NOTICE OF VIOLATION

On July 25, 2024, Energy Safety conducted an inspection of Southern California Edison Company's WMP initiatives in the vicinity of the city of Menifee, California. The inspection report is enclosed herewith. Energy Safety found the following violation(s):

INSPECTION REPORT

Item1IA1Img1: No covered conductor present.

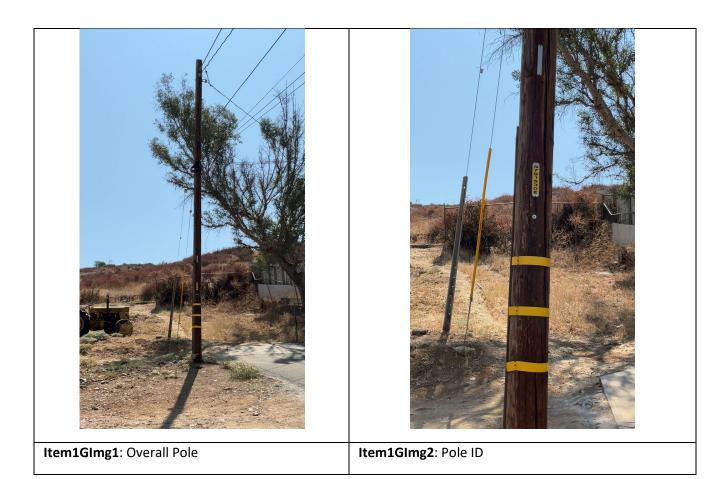
Violation 1. Energy Safety observed that in implementing 2024 WMP initiative 8.1.2.1.1 - Covered Conductor, SCE failed to provide accurate data in reporting that covered conductor was installed on Pole ID 4791530E, Grid Hardening ID TD2090512-4791530E, at coordinates 33.70752576471524, -117.2408927648505. Energy Safety considers this data accuracy violation to be in the Minor risk category.

On Pole ID 4791530E, Grid Hardening ID TD2090512-4791530E, at 23752-23998 Mount Vernon PI, Menifee, CA, 92587, USA, 33.70752576471524, -117.2408927648505, the inspector observed that no covered conductor was present. The inspector's observation is documented in Violation 1 photographs, which are attachments to this report. Photo numbers Item1GImg1, Item1GImg2, Item1IA1Img1 depict that no covered conductor was installed at the location.

Violation 1
